Display

Date: **March 12, 2001**

Model: **PVM-5041Q, PVM-6041QM**

Subject: **DISPLAY DISAPPEARS DUE TO PROTECTION CIRCUIT FUNCTION**

Figure 1

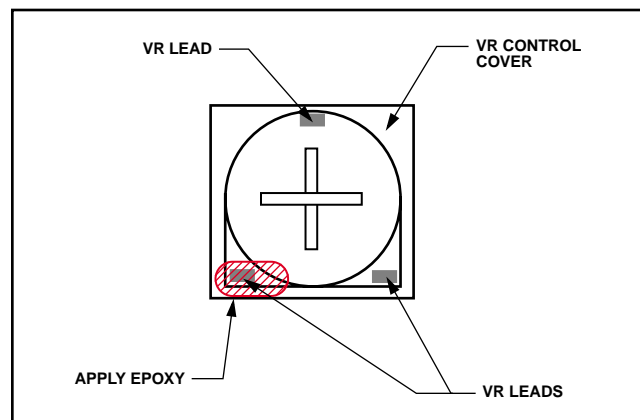
On the D board, replace RV833 (side B, zone B-12) and perform the following adjustment. (See Figure 1.)

3. Input a 100% white signal.
4. Set CONTRAST and BRIGHT controls to MAX.
5. Confirm that the meter shows 14 ± 3.0 Vdc.
6. Input a dot signal.
7. Adjust BRIGHT and CONTRAST controls so that the meter shows $I_{ABL} = 130 \pm 30 \mu A$.
8. Apply voltage from an external DC source to TP85 and adjust RV833 so that the hold-down circuit operates at 16.4 ± 0.1 Vdc.

NOTE: Do not use the 16.8 ± 0.1 Vdc measurement indicated in the service manual (section 4, page 18).

9. Apply voltage from an external DC source to TP85 and confirm that the hold-down circuit does not operate at 15.7 ± 0.1 Vdc.
10. Input a 100% white signal.
11. Adjust BRIGHT and CONTRAST controls so that the meter shows $I_{ABL} = 300 \pm 30 \mu A$.
12. Apply voltage from an external DC source to TP85 and confirm that the hold-down circuit operates at 16.1 ± 0.1 Vdc.
13. Apply voltage from an external DC source to TP85 and confirm that the hold-down circuit does not operate at 15.5 ± 0.1 Vdc.
14. After the adjustment, apply resin epoxy to RV833 only on the side with two leads. (See Figure 1.)
15. Apply only a small amount of epoxy. Take care that the epoxy does not reach the VR leads on the other side of the board.
